**ADDENDUM NO. 1
TO THE
BIDDING DOCUMENTS
FOR
MILL CREEK WRF ELECTRICAL AND PROCESS IMPROVEMENTS
FOR
LAKE COUNTY PUBLIC WORKS**

LAKE COUNTY BID NO. 17223

DATE: December 21, 2017

LAKE COUNTY DEPT. OF PUBLIC WORKS
MILL CREEK WRF
ELECTRICAL AND PROCESS IMPROVEMENTS
COUNTY OF LAKE, IL
SITE DEVELOPMENT
ELECTRICAL SITE PLAN

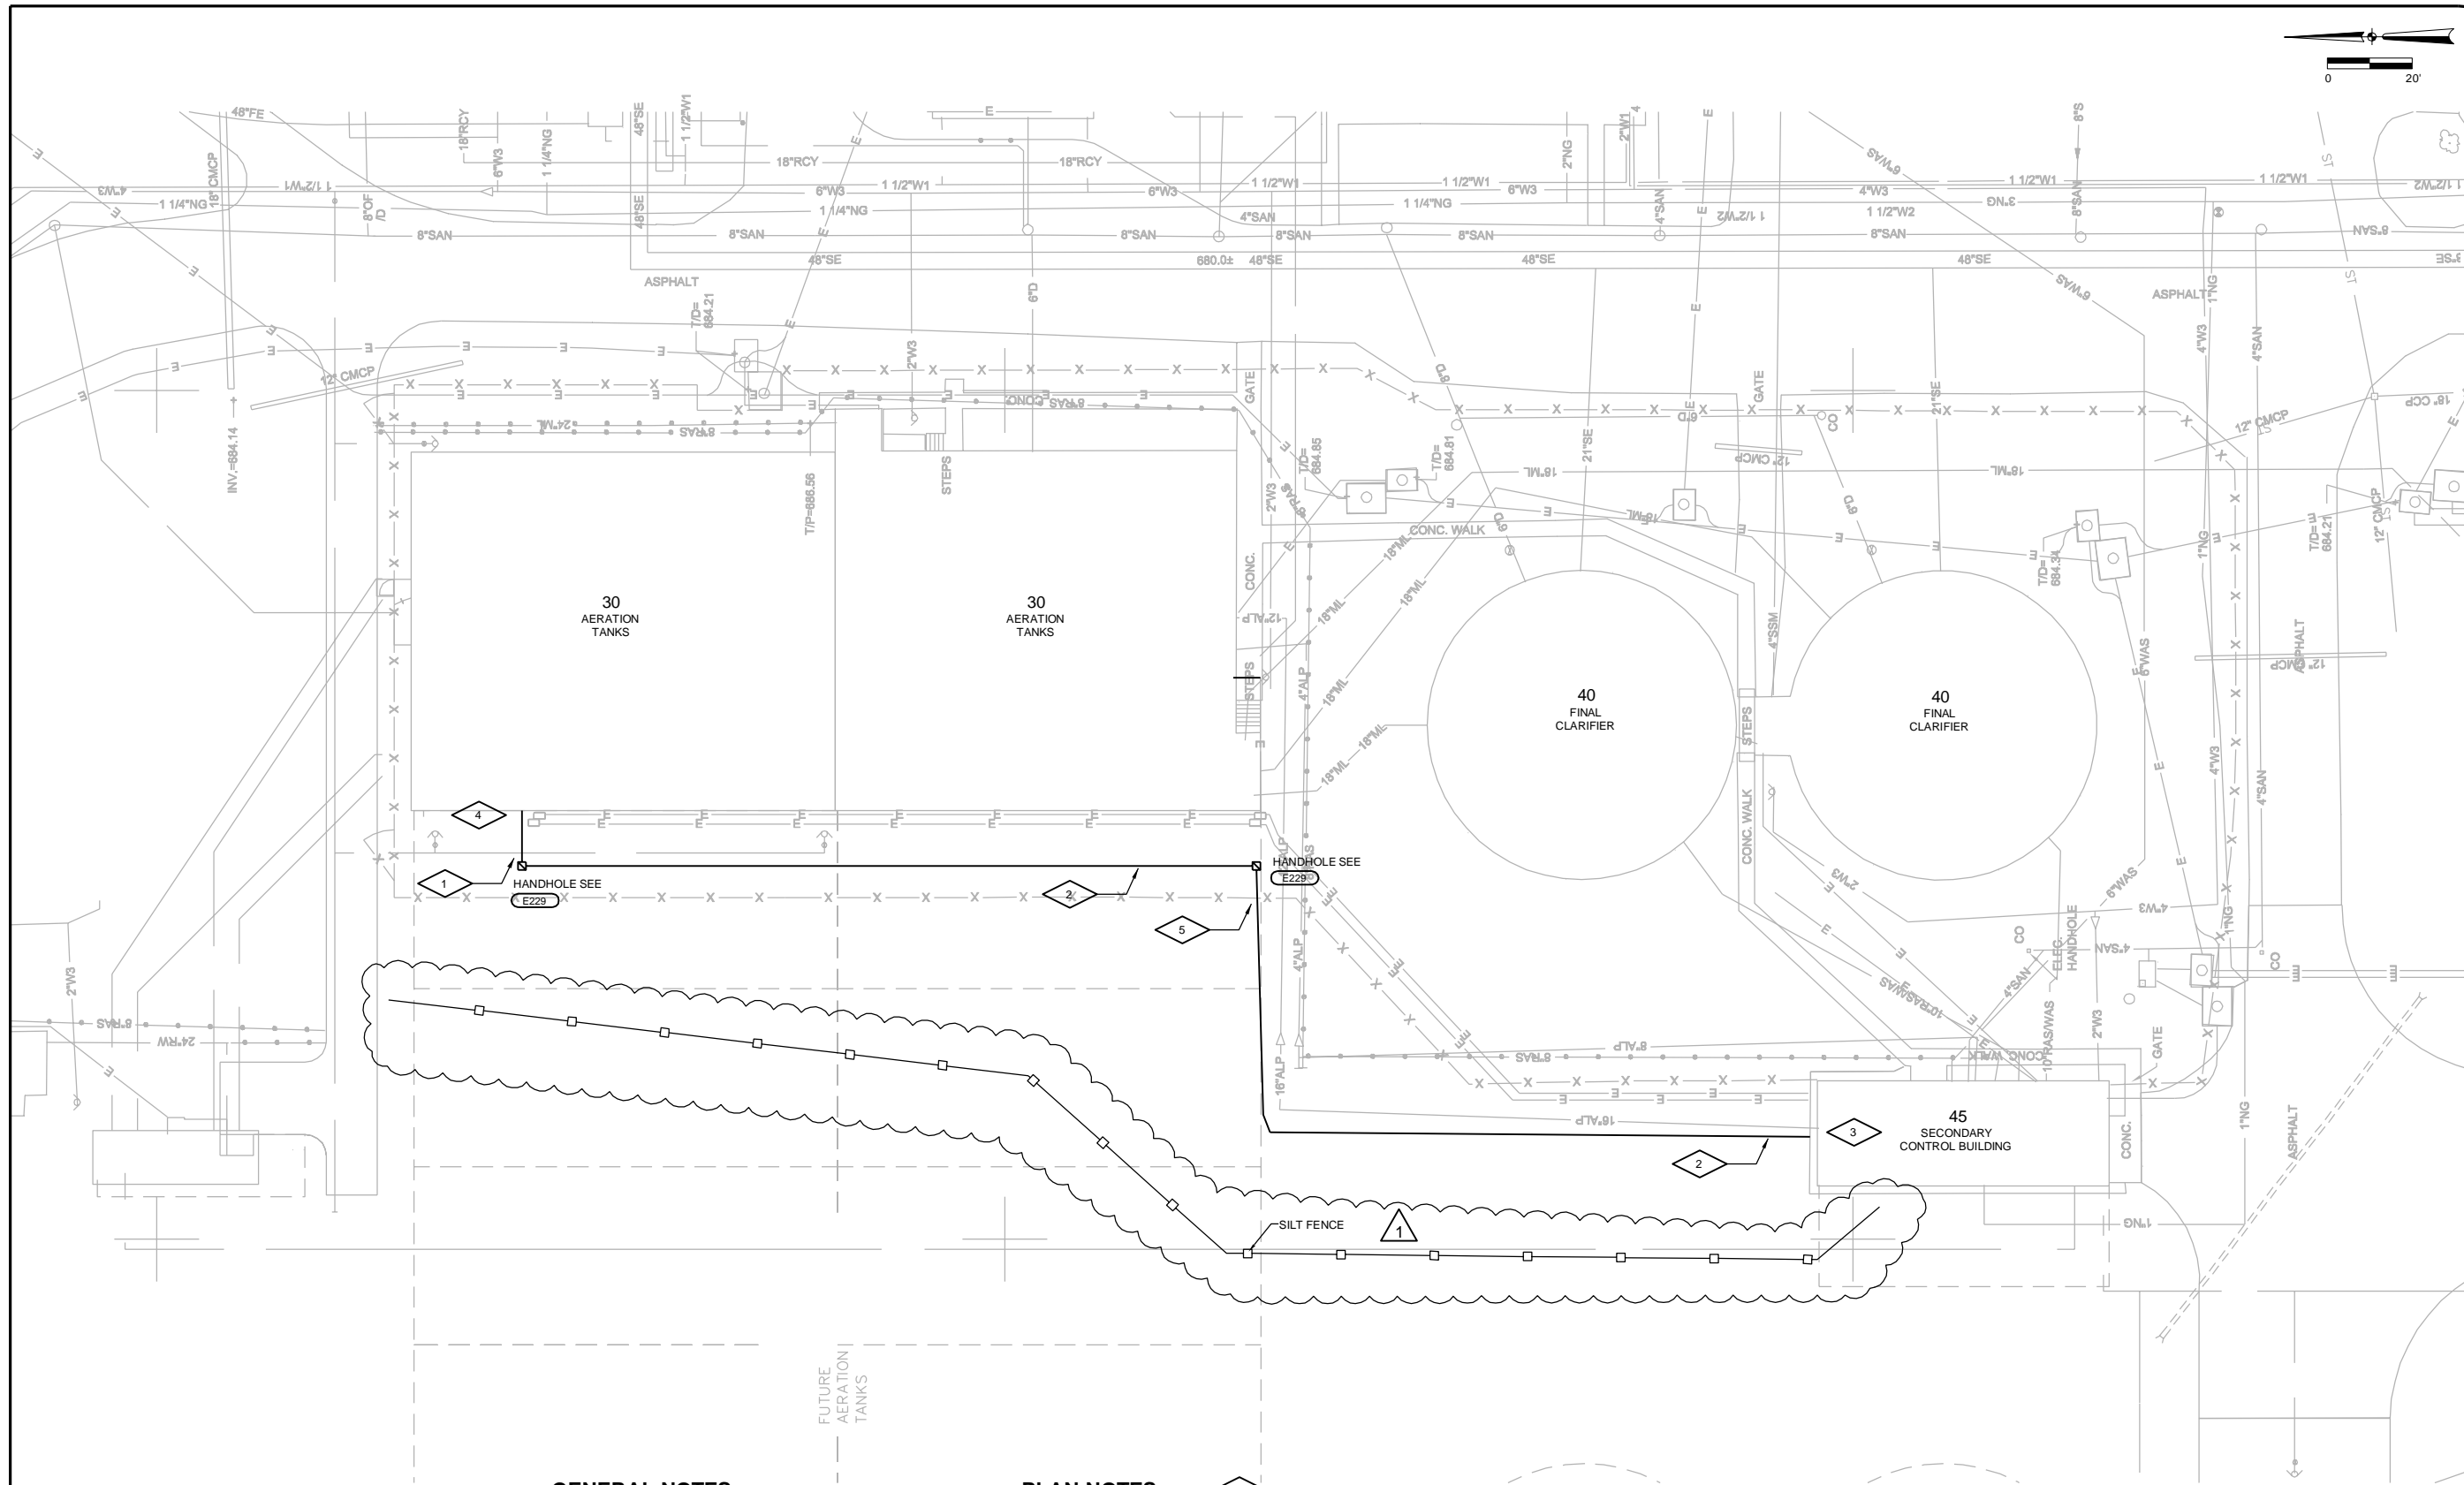
- A. Sheet 9 (Drawing 002-E-1): Replace entire sheet with Sheet 9 attached to this Addendum.
- B. Sheet 41 (Drawing 999-E-1): Add note to Detail E100 reading "duct bank concrete shall be dyed red"
- C. Sheet 41 (Drawing 999-E-1): in Detail E600, remove the words "PVC-Coated GRS" from all notes in this detail and replace with the word "GRS".
